ADDENDUM NUMBER 1

PROJECT	BIDS DUE
Village of Central Lake Sanitary Sewer Improvements Division B – Pump Station Replacement GFA Project No: 21006	Date: August 27, 2026 Time: 9:30 AM Location: Village of Central Lake 2530 N Main St Central Lake, MI 49622

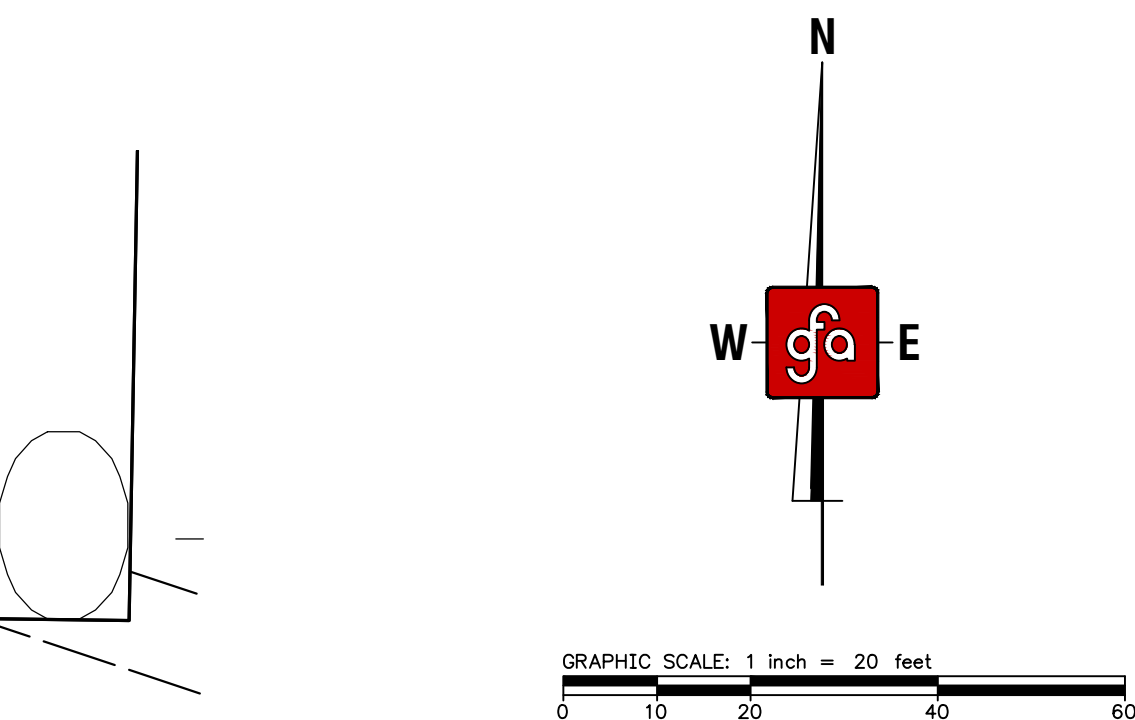
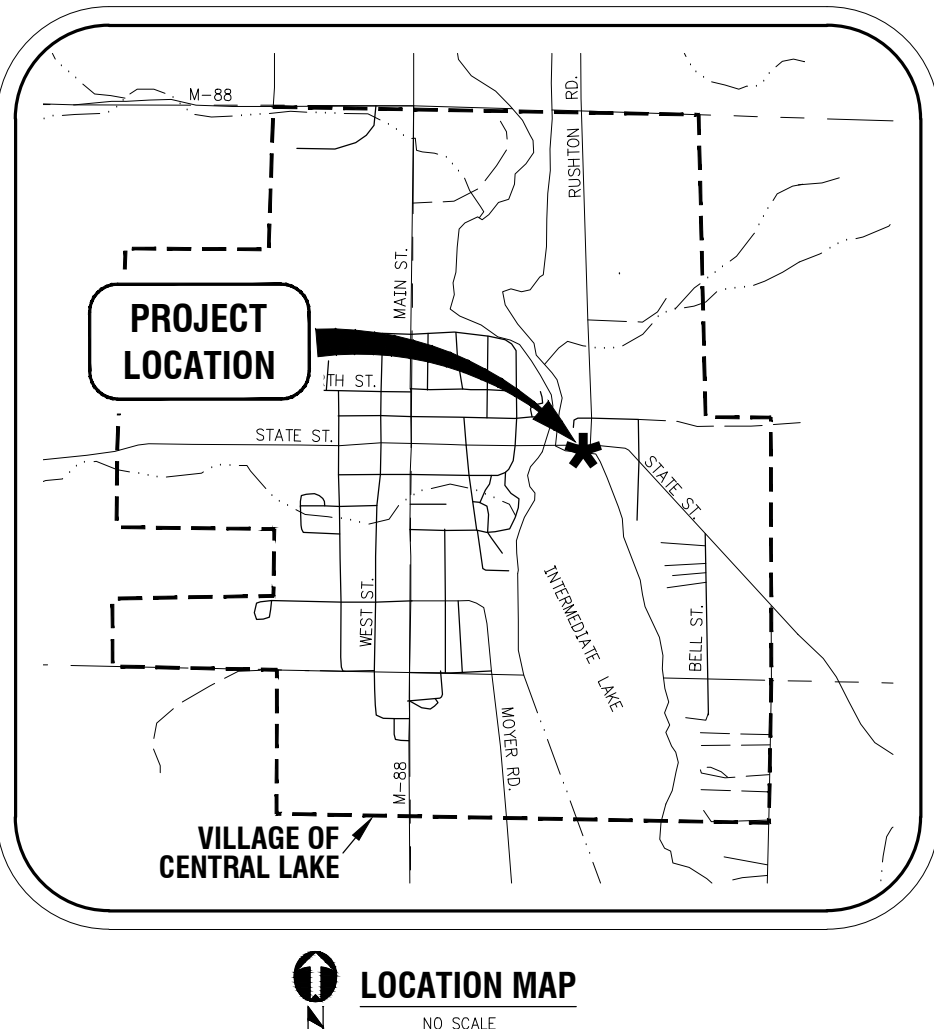
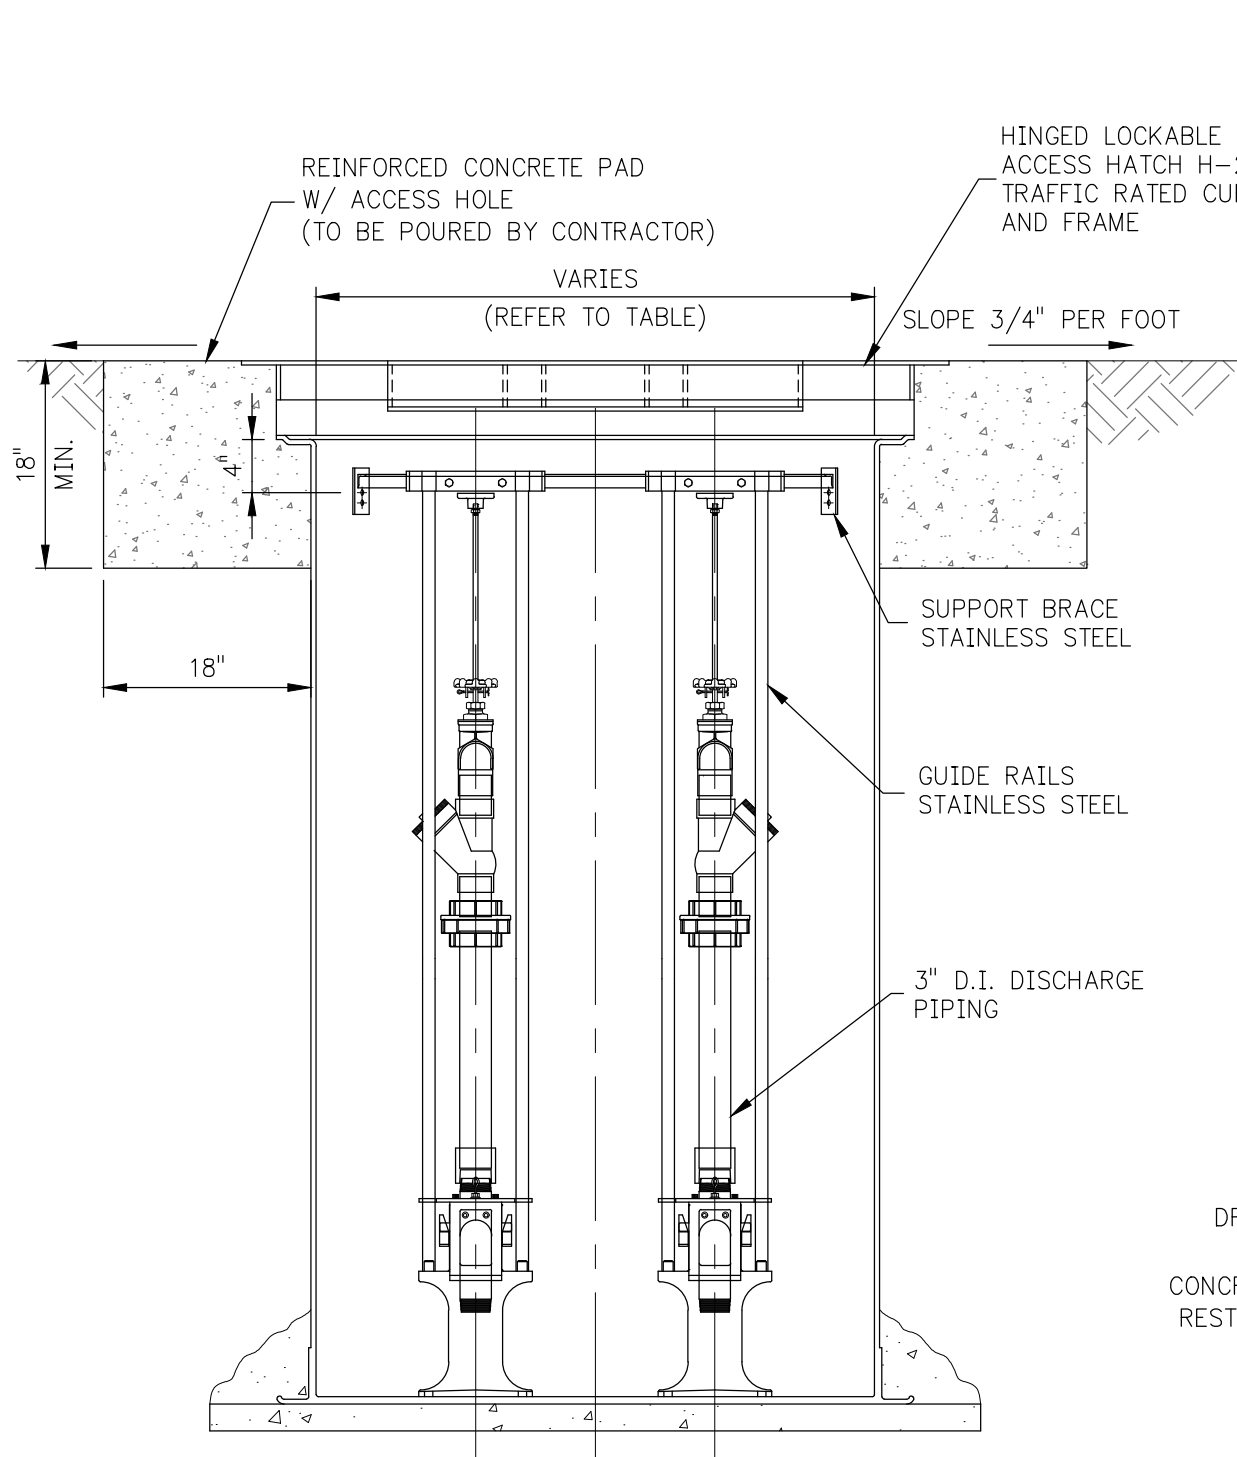
1. Sheet C1.1 included with this addendum shall be incorporated into the bid documents.
2. Sheet C2.2 shall be stricken in its' entirety and shall be replaced with the attached and incorporated into the bid documents. The changes are clouded and illustrate recent site updates that were implemented to include kayak launch and sidewalk that are within the vicinity of this project.

**21006
C4.2**

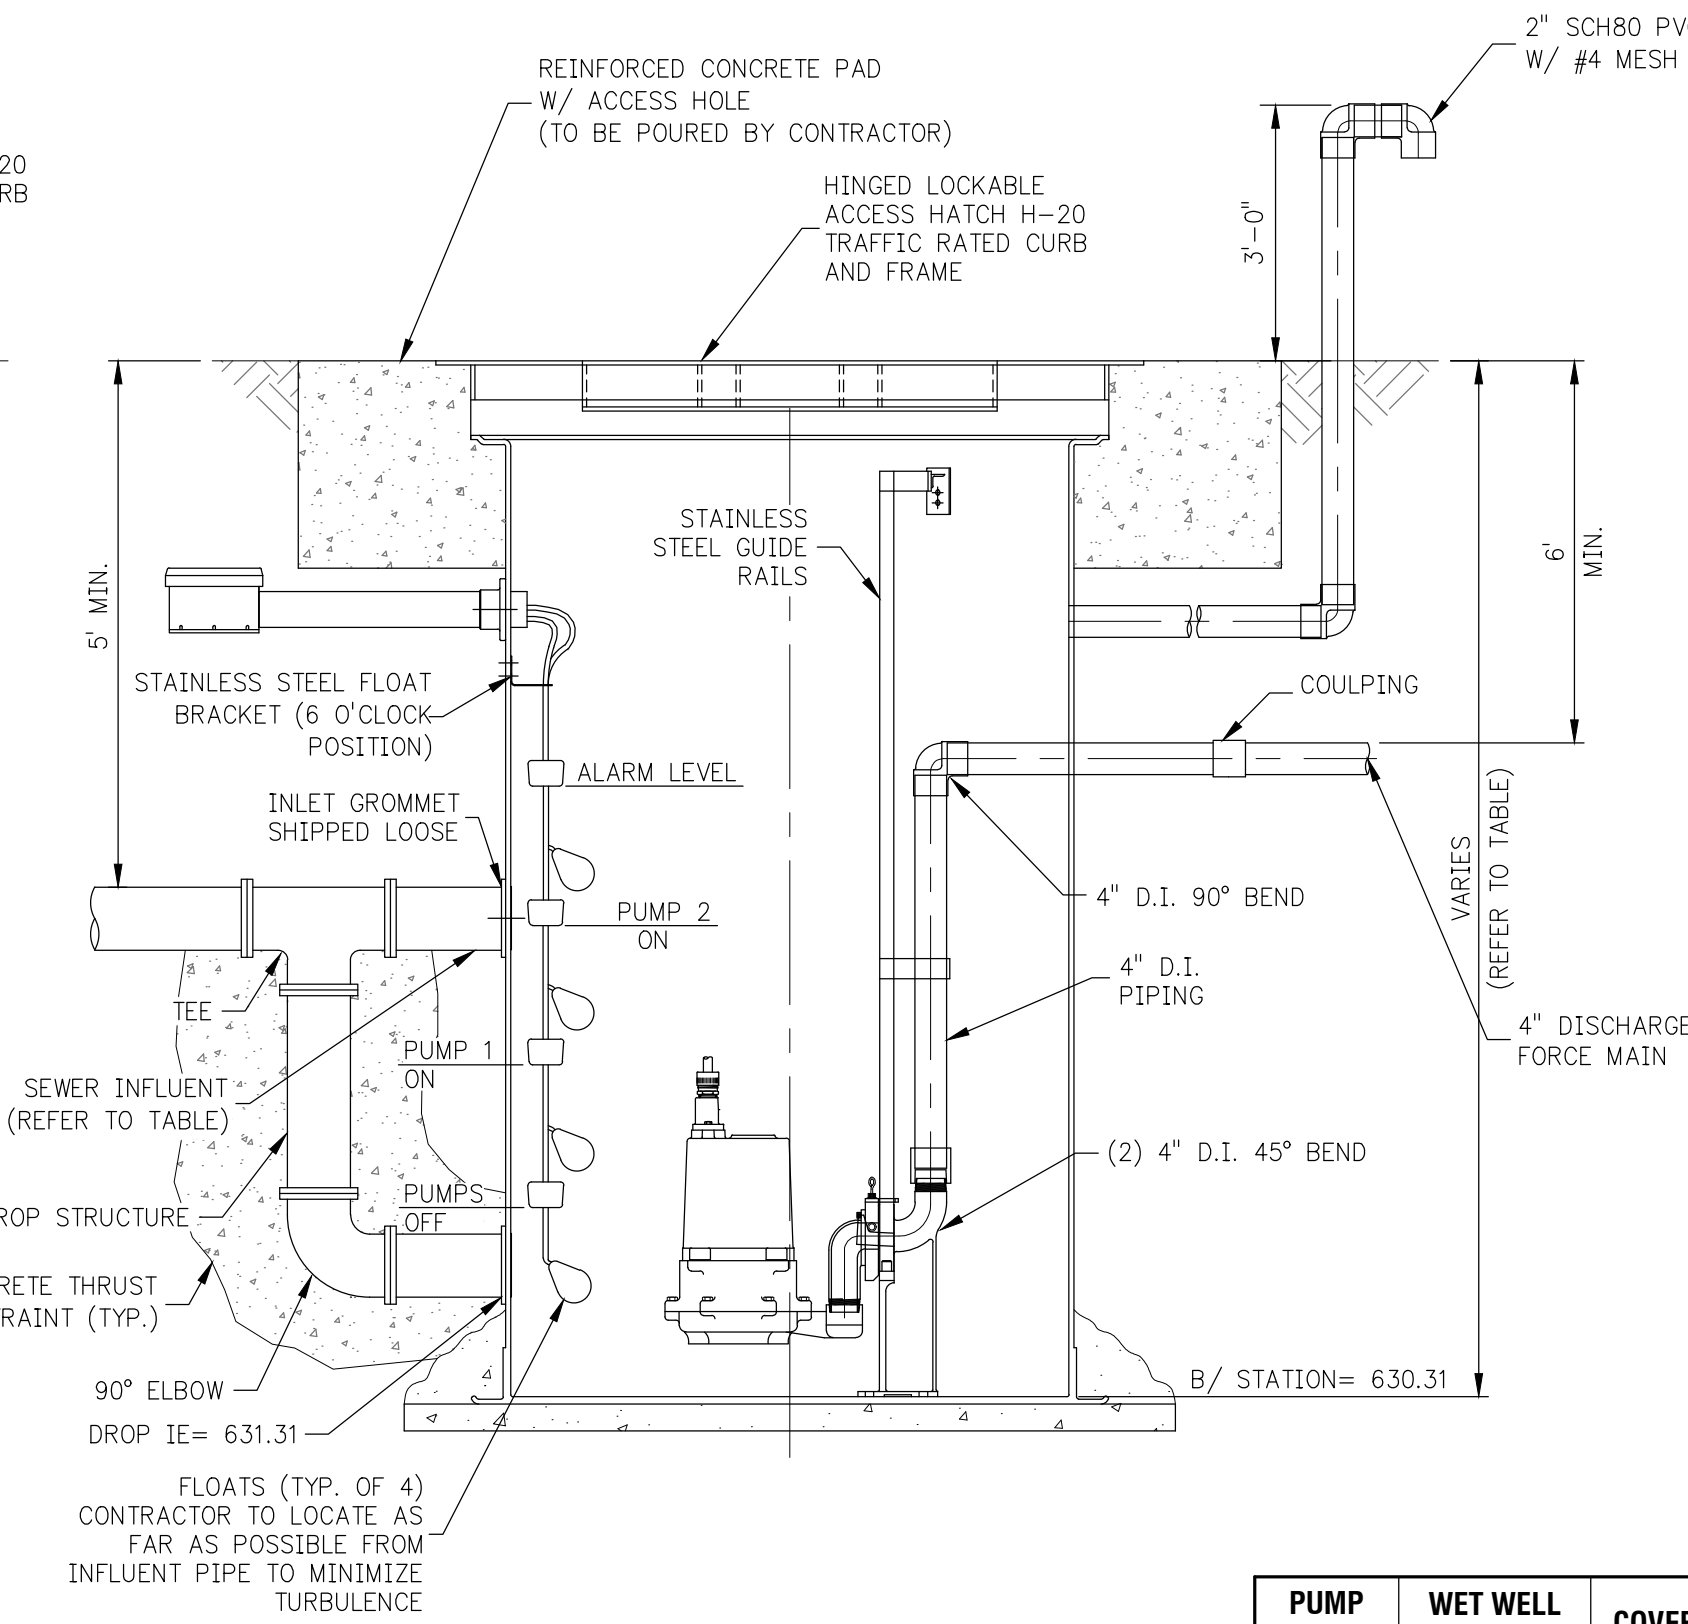
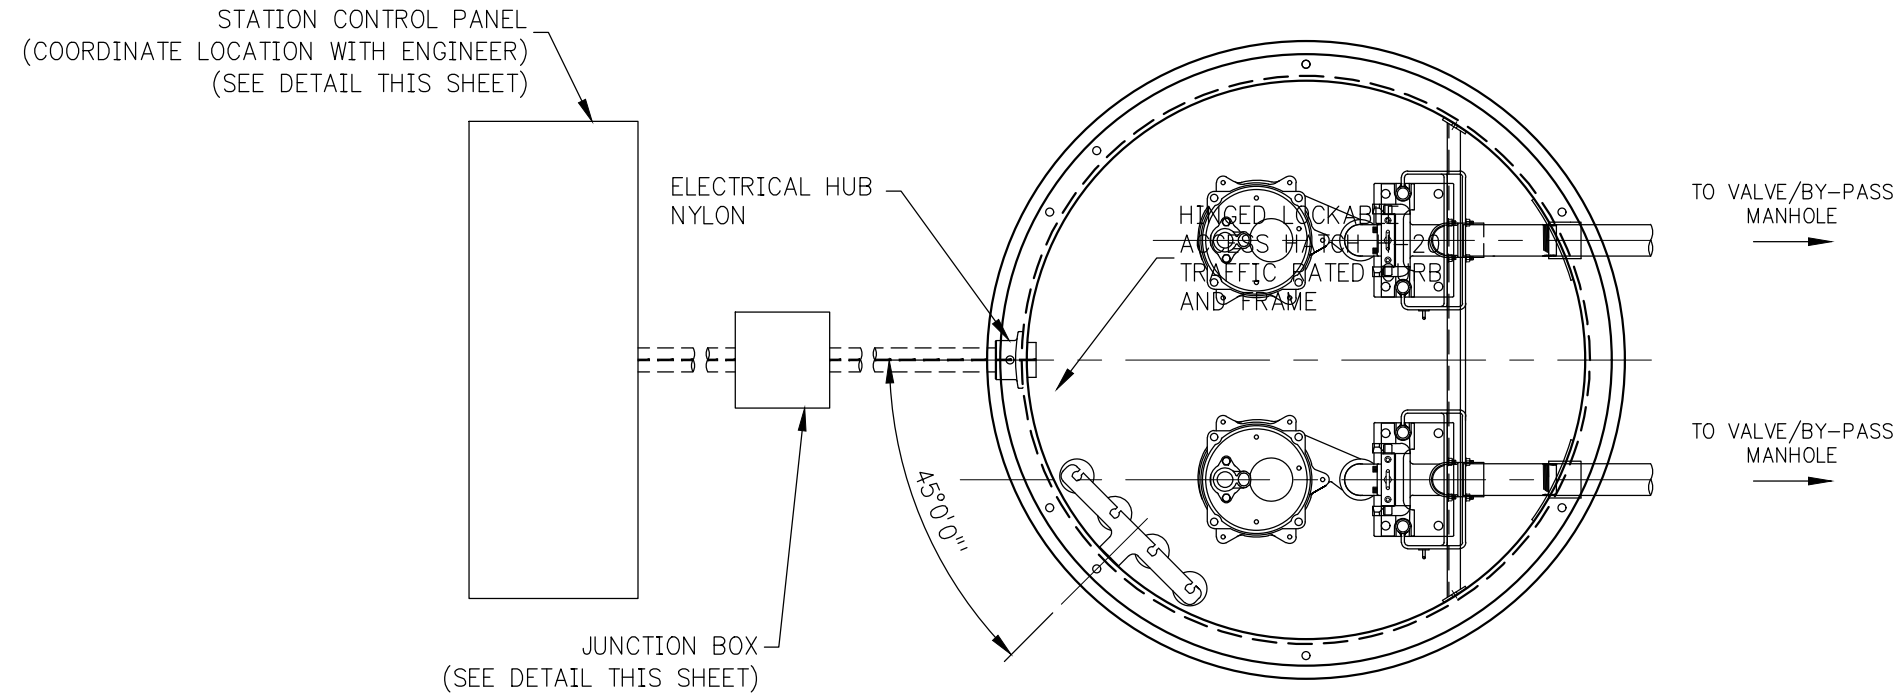
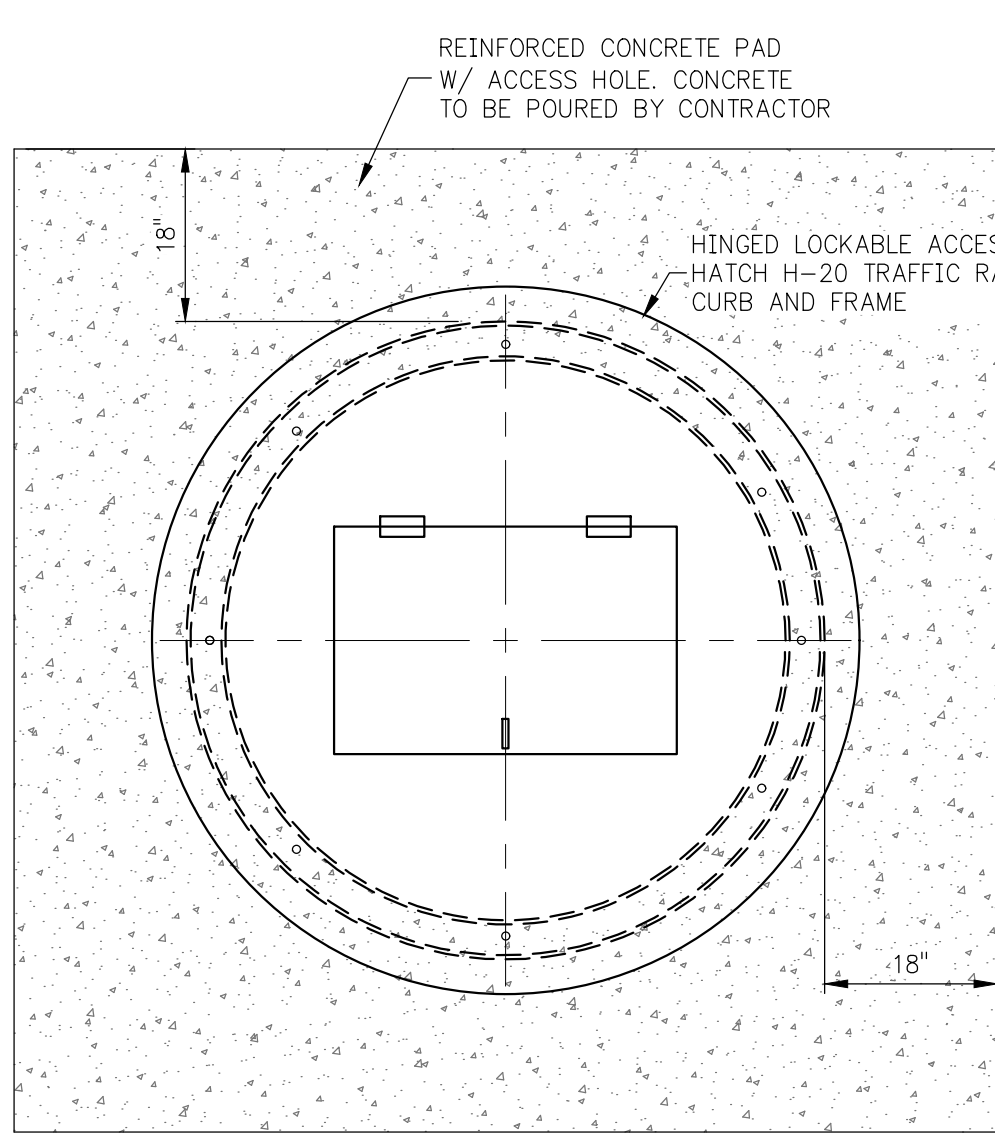
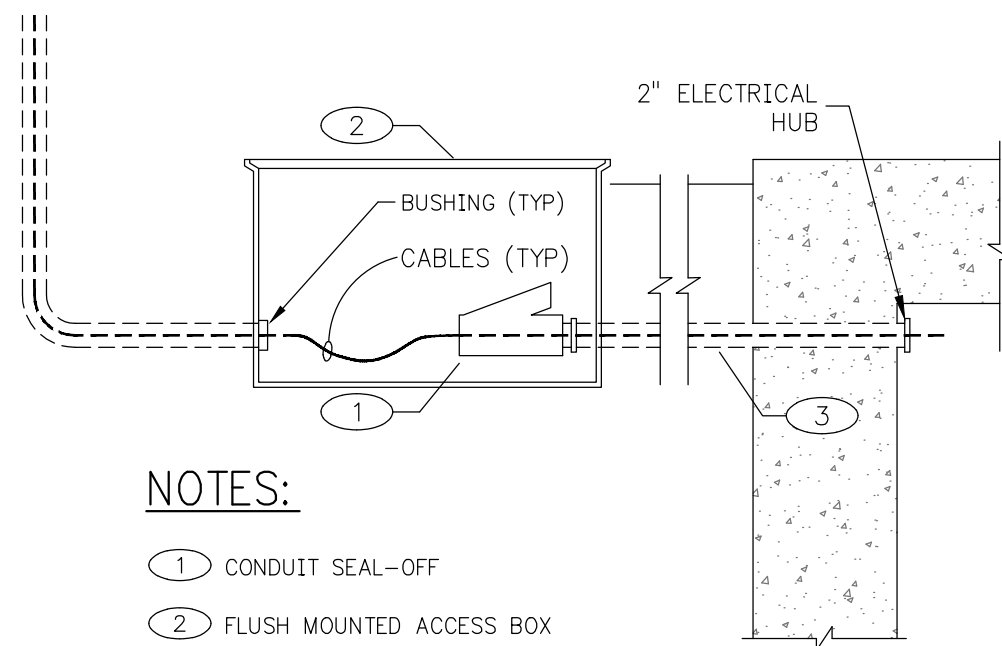
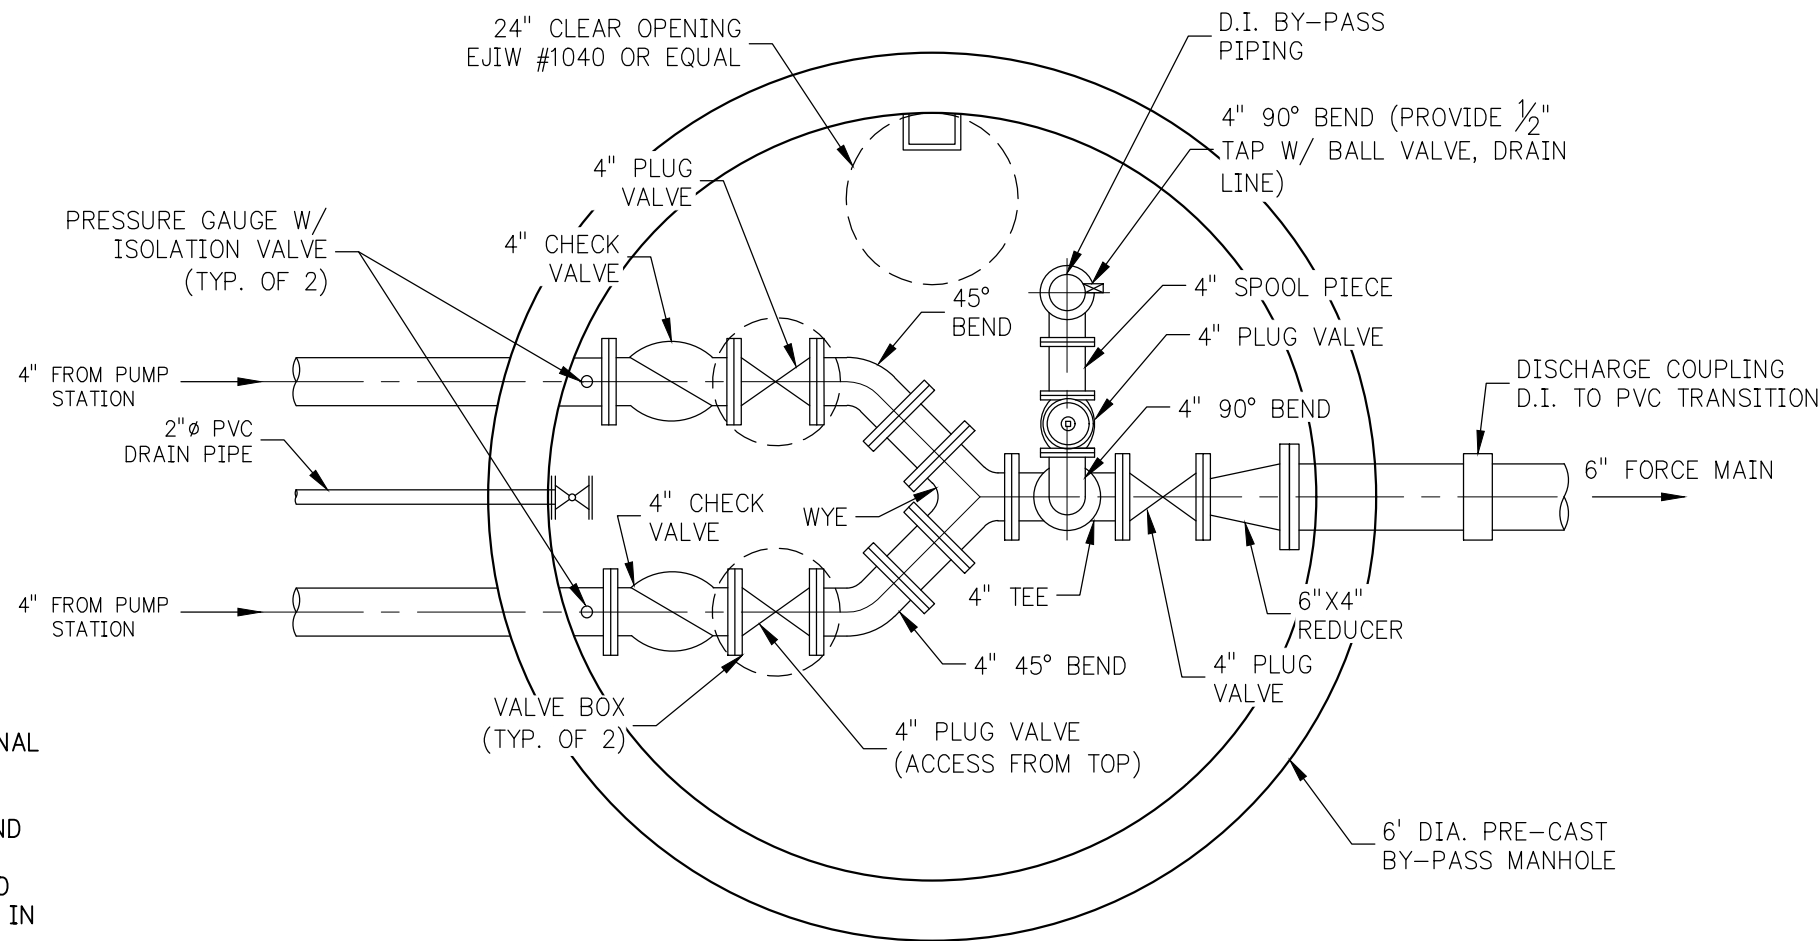
3. Sheet C4.2 shall be stricken in its' entirety and shall be replaced with the attached and incorporated into the bid documents. The proposed changes are clouded and provide additional wiring and conduit information pertinent to the proposed generator. In addition, further clarification and information is provided as the proposed generator is intended to support both Pump Station #1 and the Village Office. All costs associated with materials, electrical, wiring, conduit, and labor are to be provided and included in the respective bid items.
